Project	IEEE 802.16 Broadband Wireless Access Working Group < http://ieee802.org/16 >
Title	Proposed text and ASN.1 code to support MOB_PAG-ADV
Date Submitted	2007-03-13
Source(s)	Joey Chou Intel Corporation [mailto:joey.chou@intel.com]
Re:	
Abstract	This contribution proposes the text and ASN.1 code in wmanIf2mMib to support MOB_PAG-ADV message.
Purpose	Adoption
Notice	This document has been prepared to assist IEEE 802.16. It is offered as a basis for discussion and is not binding on the contributing individual(s) or organization(s). The material in this document is subject to change in form and content after further study. The contributor(s) reserve(s) the right to add, amend or withdraw material contained herein.
Release	The contributor grants a free, irrevocable license to the IEEE to incorporate material contained in this contribution, and any modifications thereof, in the creation of an IEEE Standards publication; to copyright in the IEEE's name any IEEE Standards publication even though it may include portions of this contribution; and at the IEEE's sole discretion to permit others to reproduce in whole or in part the resulting IEEE Standards publication. The contributor als

Figure 19—wmanIf2mBsCm structure

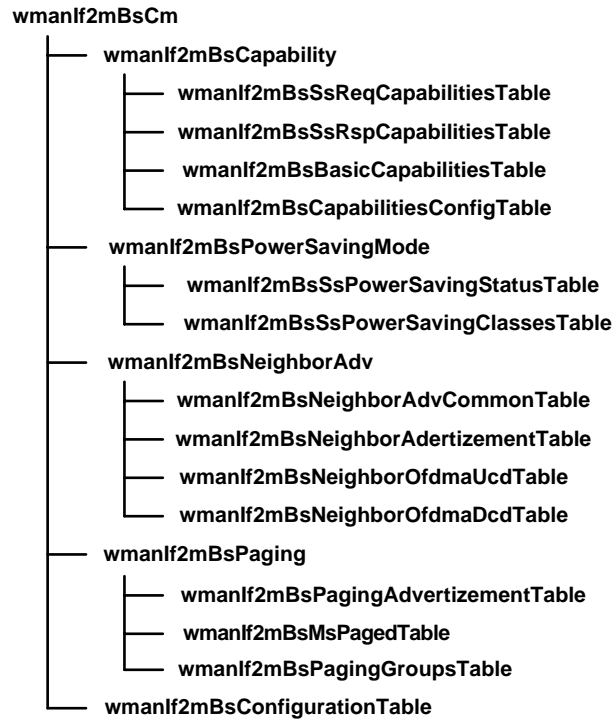
[Change Figure 19 as the following:]
